Zoning Permit

Permit Number ZP-2023-011679

PROPOSED MULTIFAMILY RESIDENCE
2000 SPRING GARDEN STREET
PHILADELPHIA, PENNSYLVANIA
PROJECT
DWG. TITLE
ZONING PLAN & ELEVATIONS

Notice of: ☒ **Refusal** ☐ **Referral**

Z-2

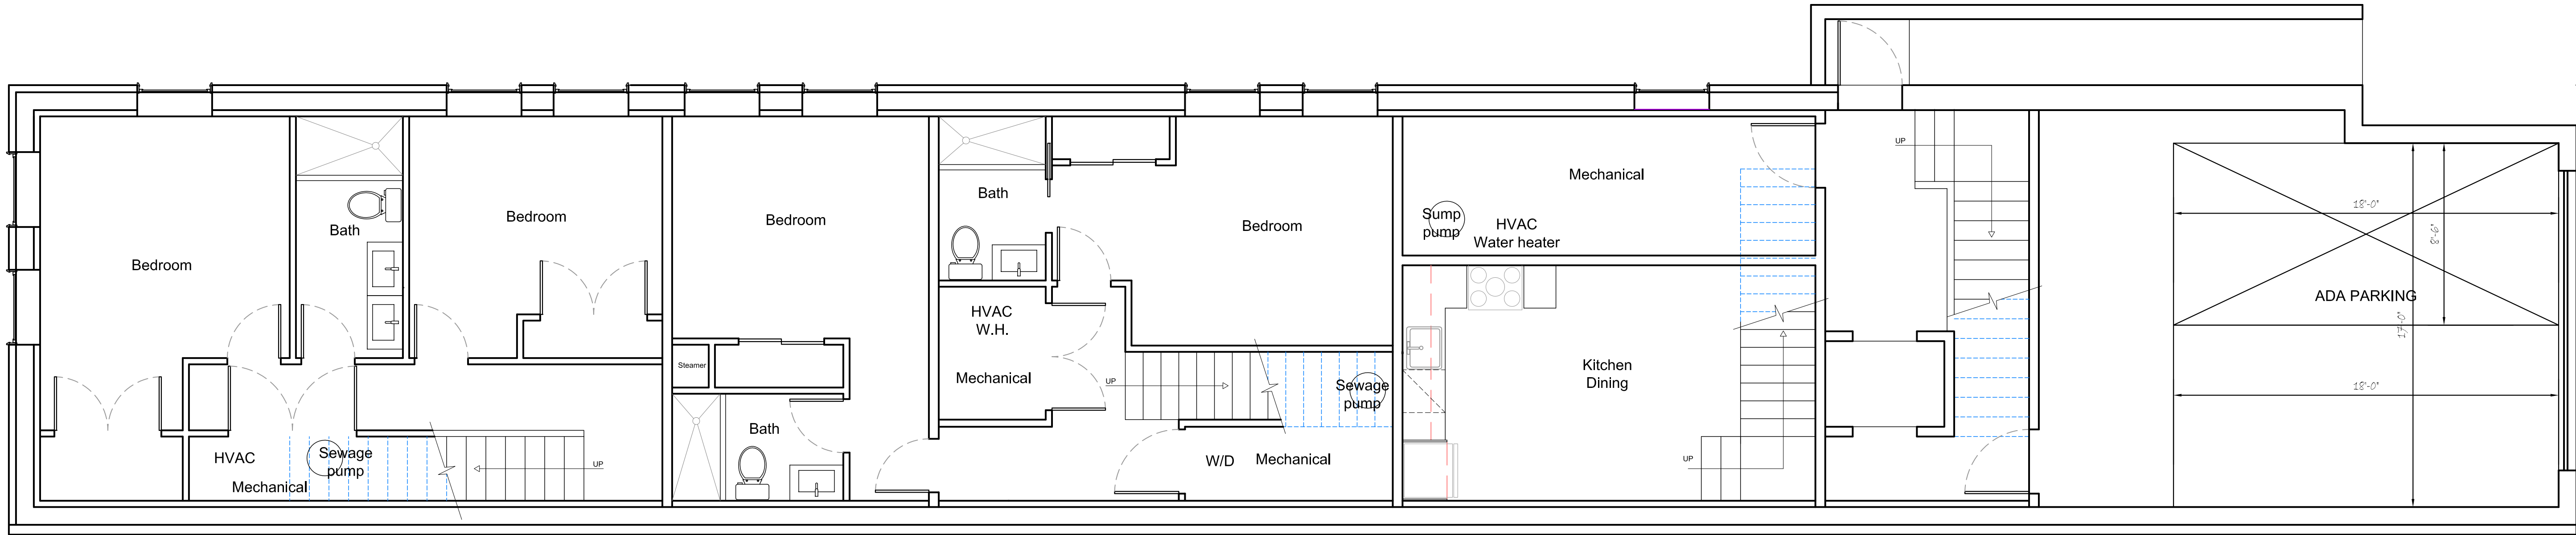
CODE REFERENCE	PROPOSED USE IS REFUSED FOR THE FOLLOWING:
§12-803 (1) (c); §14-701 (1) (.1) (.a);	THE PROPOSED ACCESSORY PARKING SPACES FOR MULTI-FAMILY USE IN AN ATTACHED BUILDING, ACCESSED FROM FRONT STREET, IS EXPRESSLY PROHIBITED IN THIS ZONING DISTRICT, RM-1.
